# **87C196JR SPECIFICATION UPDATE**

Order Number: 272858-003

The 87C196JR may contain design defects or errors known as errata. Characterized errata that may cause the 87C196JR's behavior to deviate from published specifications are documented in this specification update.

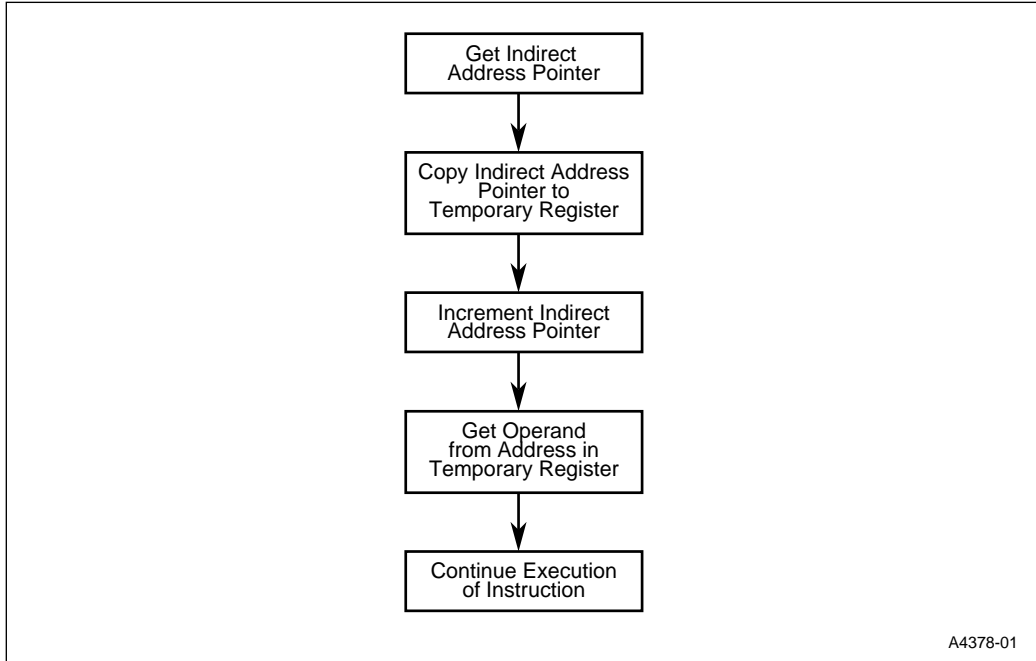
- Check for pending EPAX interrupts before exiting an EPAX ISR

Another method for avoiding this situation is to check for pending EPA interrupts before exiting the EPA interrupt service routine. This is an easy way to detect overruns and additional interrupts. It can also save loop time by eliminating the latency necessary to service the pending interrupt. However, this method cannot be used with the peripheral transaction server (PTS).

**Figure 1. 16-bit System with EPROM**

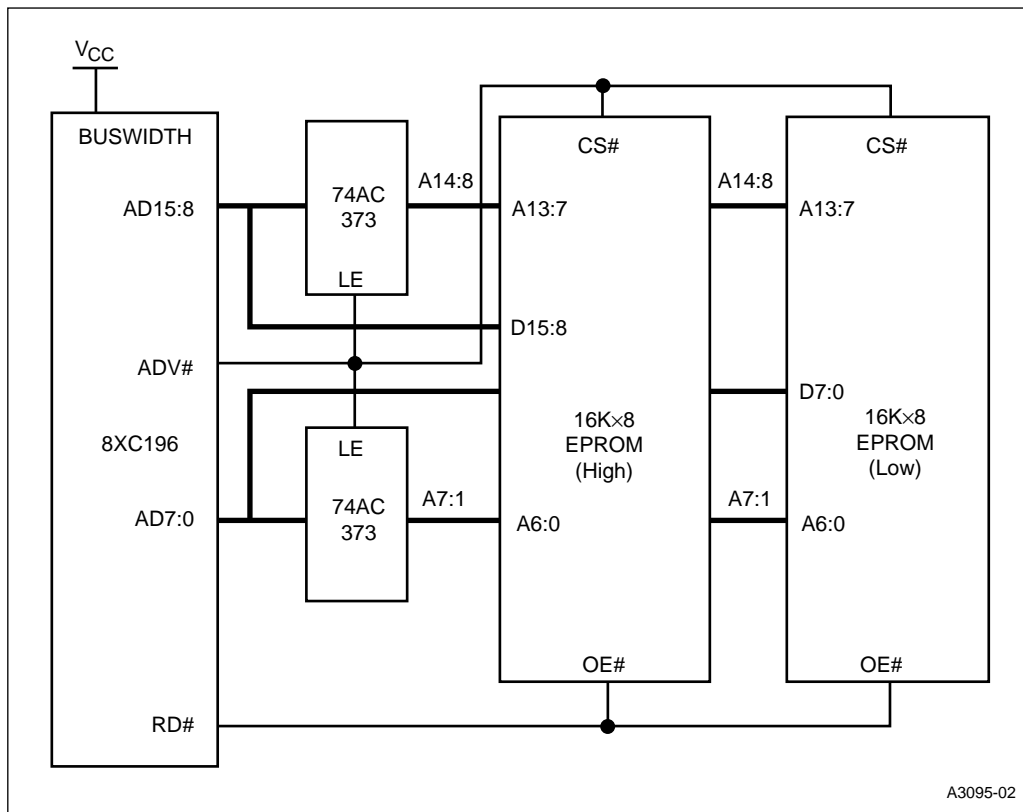
**001.** *High address inputs to the low EPROM should be A14:8 in Figure 15-18.*

**ITEM:** The next revision of the user's manual will include the following corrected graphic.
